City of Lee's Summit

Change Order Details

Water Tower Re-Coatings (Scherer and Woods Chapel)

To:	Lee's Summit Water Utilities Department Attn: Mr. Jeff Thorn 1200 SE Hamblen Road Lee's Summit, MO 64081
From:	Kevin Waldron, PE
RE:	Water Tower Re-Coating Phase 2 – Woods Chapel and Scherer Lee's Summit, Missouri - 2022 Additional and Revised Recommendations
Date:	December 20, 2022
Project #:	C17-0717

PHOTO #3

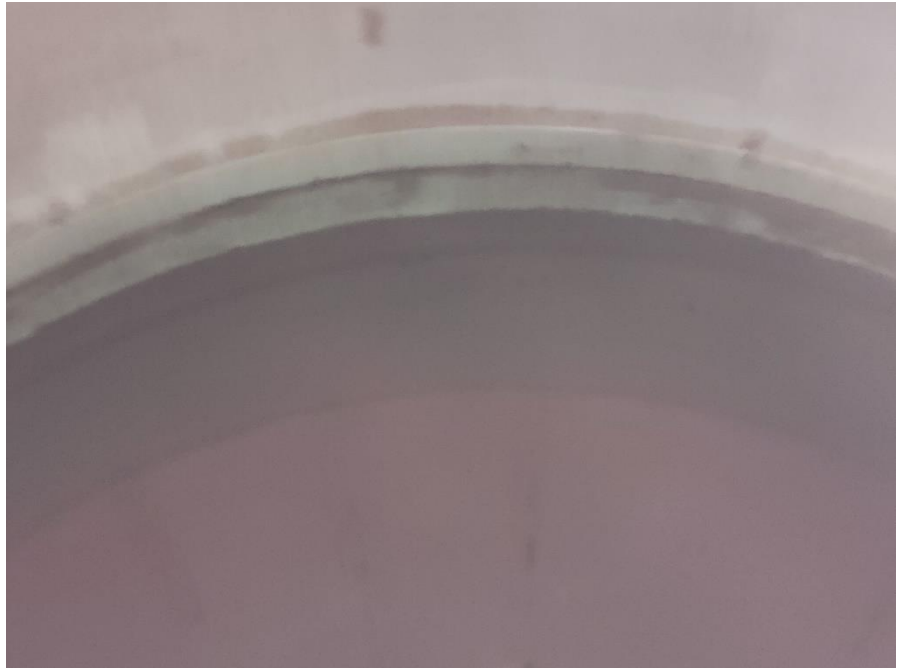
Area of bottom where belly meets the shell.

PHOTO #5

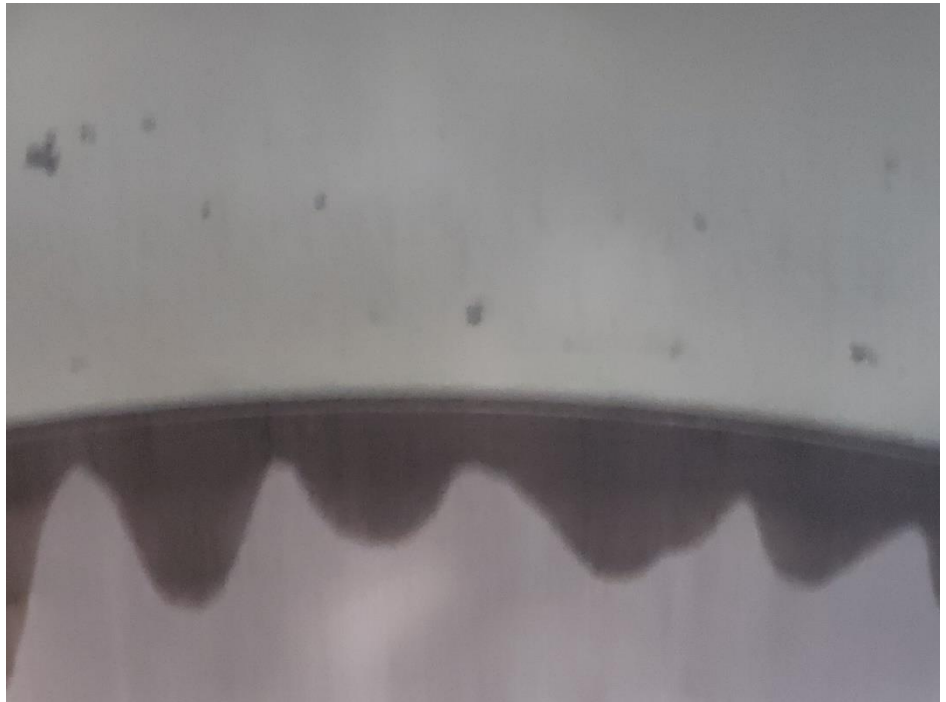
Area where the shell meets the belly.

PHOTO #7

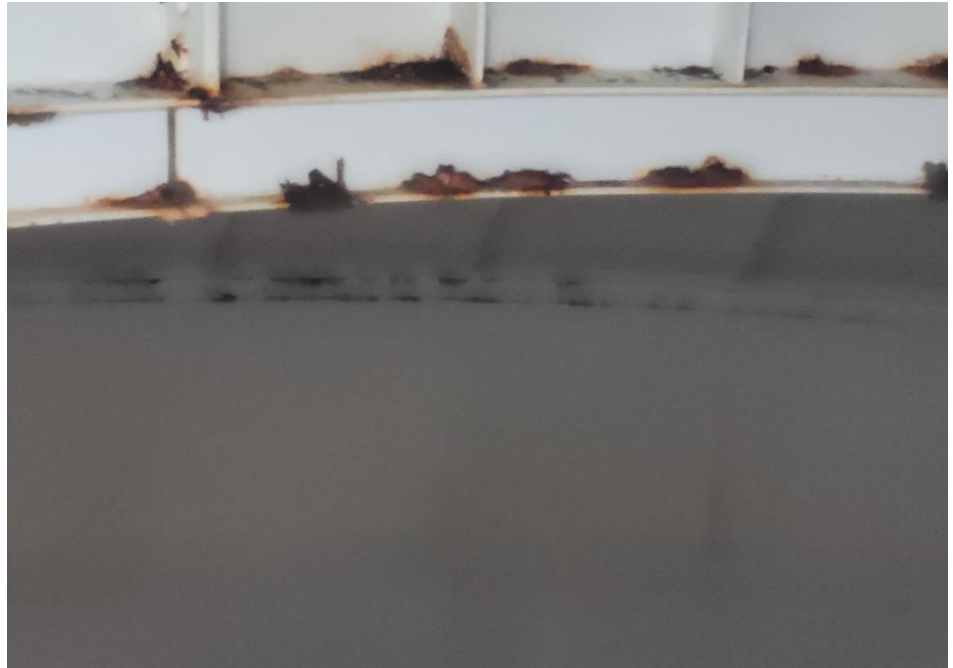
Painters rail with corrosion.

Item No.	Description
1	Remove interior painter's rails per Contractor's attached proposal dated 12/6/22.
2	Install exterior containment weld plates per Contractor's attached proposal dated 12/8/22.
